# United States Patent and Trademark Office

APPLICATION NO.	FILING DATE	FIRST NAMED INVENTOR	ATTORNEY DOCKET NO.	CONFIRMATION NO.	
10/691,161	10/22/2003	Gianni Borghi	U 014865-4	6515	
7:	7590 04/05/2006			EXAMINER	
LADAS & PARRY 26 West 61st Street			CHARLES, MARCUS		
NEW YORK, NY 10023			ART UNIT	PAPER NUMBER	
ŕ	,		3682

#### **DETAILED ACTION**

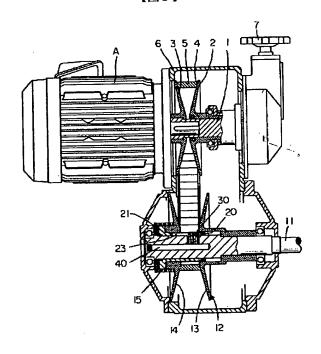
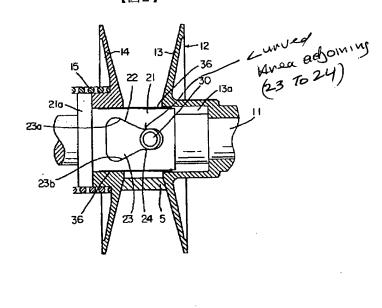
- 7. Claim 1-5 are rejected under 35 U.S.C. 102(b) as being anticipated by JP (2002-227949) to Sakai. Sakai discloses the CVT as claimed including an axial thrust compensating device (23/30) comprising a first cam means (30, 23a and the curved area adjoining 23a to 24 see attached drawing) interposed between the fix pulley half (12) and the movable pulley (14) half to generate axial thrust on the movable pulley half in the compression direction of the belt (5) in response to the drive torque; the compensating device comprises a second cam means (30, 32b and curved area adjoining 23b to 24, see attached drawing) interposed between the fix pulley half and the movable pulley half to generate axial thrust on the movable pulley half in the compression direction of the belt in response to a braking force.

one slot carried by one half pulley (14) and the cam follower carried by the other half pulley (12) and the first and second cam slot means being defined by respective sides 23a/23b (including the curve adjoining 23a/b to 24) defining the slot (23) of the cam circumferentially and the sloping in opposite directions at least along respective portions.

In claim 3, note the axial portion of (24). It is apparent the belt is at its maximum clamping force when the roller is in the straight slot along the axis and thus the pulley is at the maximum speed range.

In claim 4, it is apparent that the sleeve (21) is integral with the movable half pulley (14) and slidable on the hub (13a) of the fix pulley.

In claim 5, Sakai discloses the claimed invention in fig. 4
